# ARCHITECTURAL ADDENDUM NO. 01

Date of Issuance: April 7, 2015  
 Project: **RigOne Drilling Training Center  
 Houston Community College System**  
 Issued by: Texas-IBI Group  
 P. O. Box 891209  
 Houston, TX 77289  
 281-286-6605

Texas-IBI Group Project No.: **201321**

HCC Project No.: **CSP 15-11**

**E3.01**  
 ELECTRICAL DETAILS

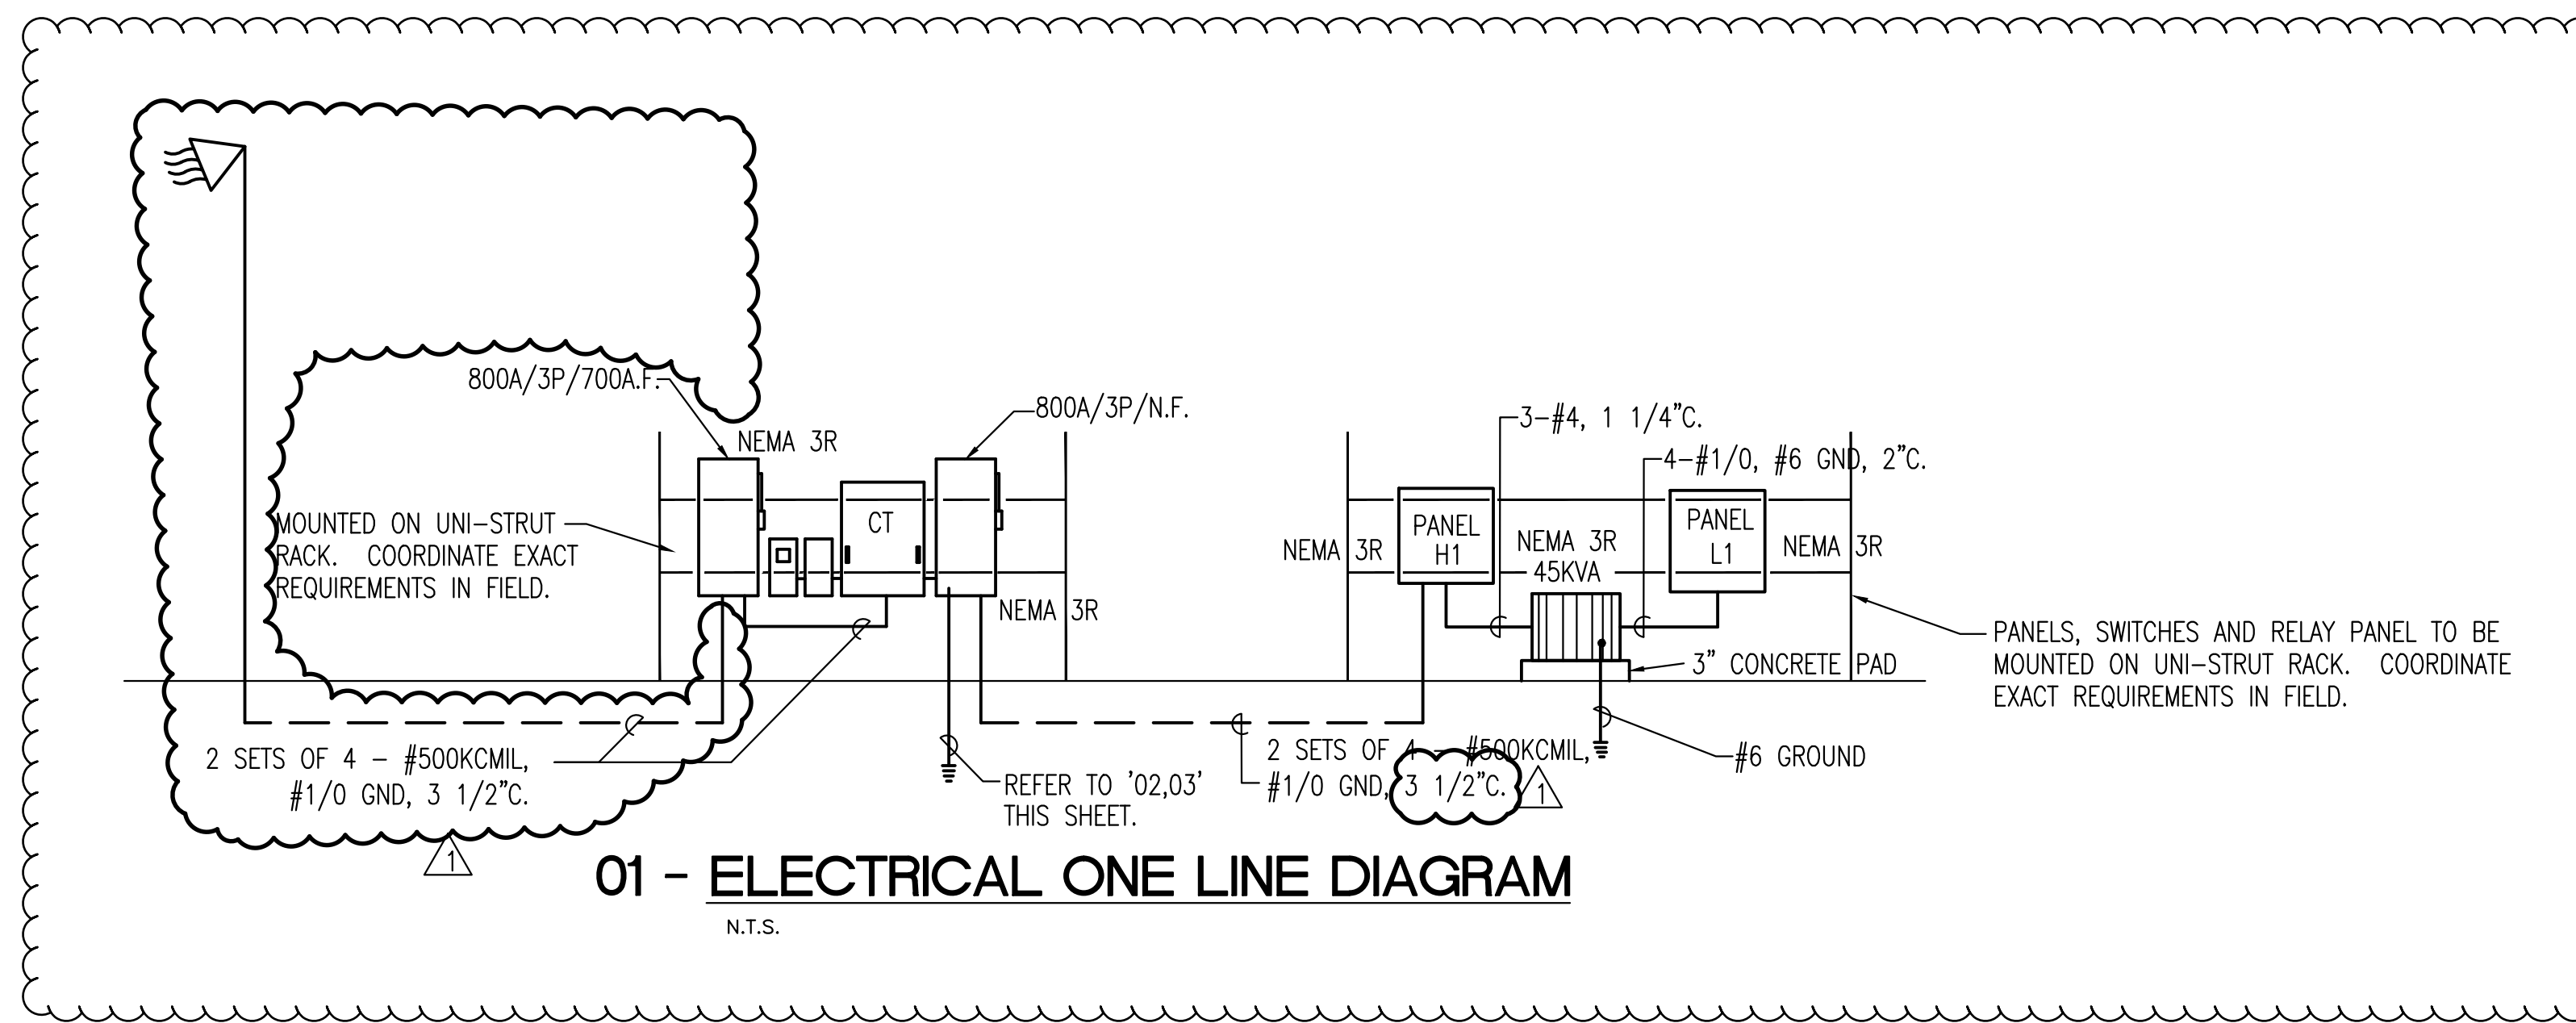
12. Sheet E3.01 Details: Detail 1 - Electrical One Line Diagram: Delete and replace in its entirety. See the attached re-issued sheet E3.01 Electrical Details.

13. Sheet E3.01 Details Detail 1 - Electrical One Line Diagram: All unistrut rack / frame vertical supports shall be embedded in a 12 inch diameter concrete footing, a minimum 18 inches deep.

**02 - SERVICE GROUNDING DETAIL**  
 NOT TO SCALE

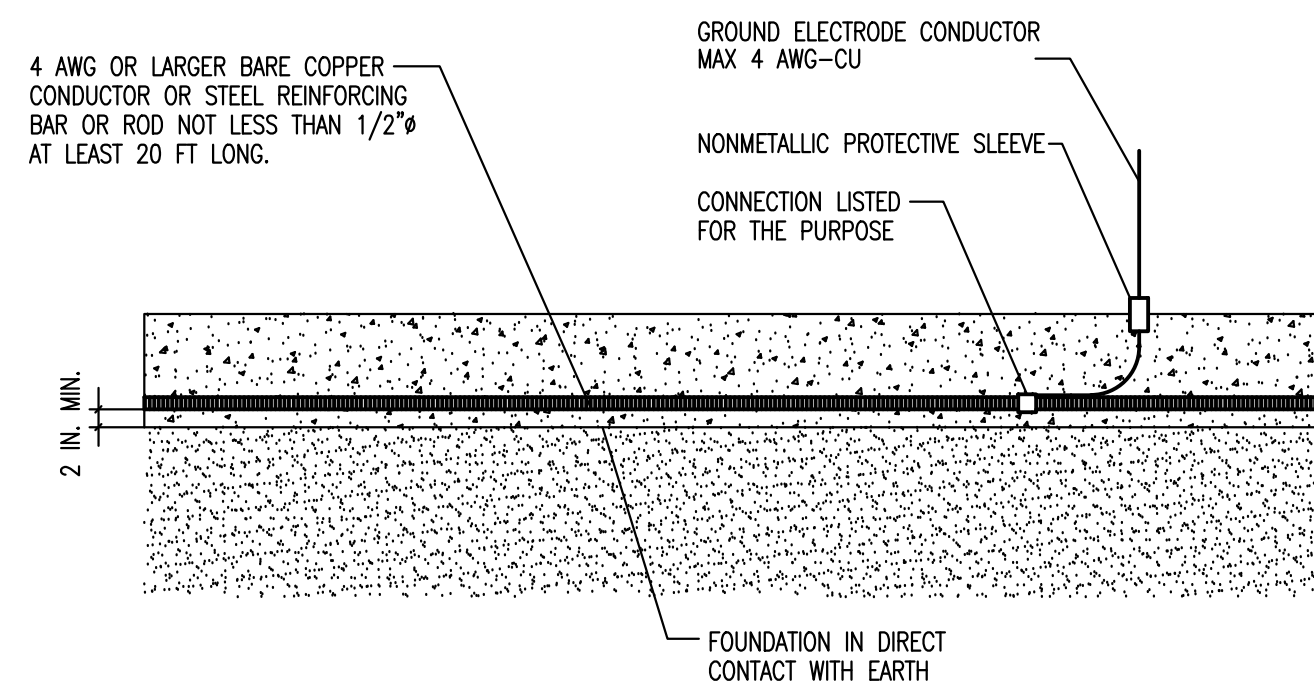
14. Sheet E3.01 Details: Detail 2 - Service Grounding Detail: Delete and replace in its entirety. See the attached re-issued sheet E3.01 Electrical Details.
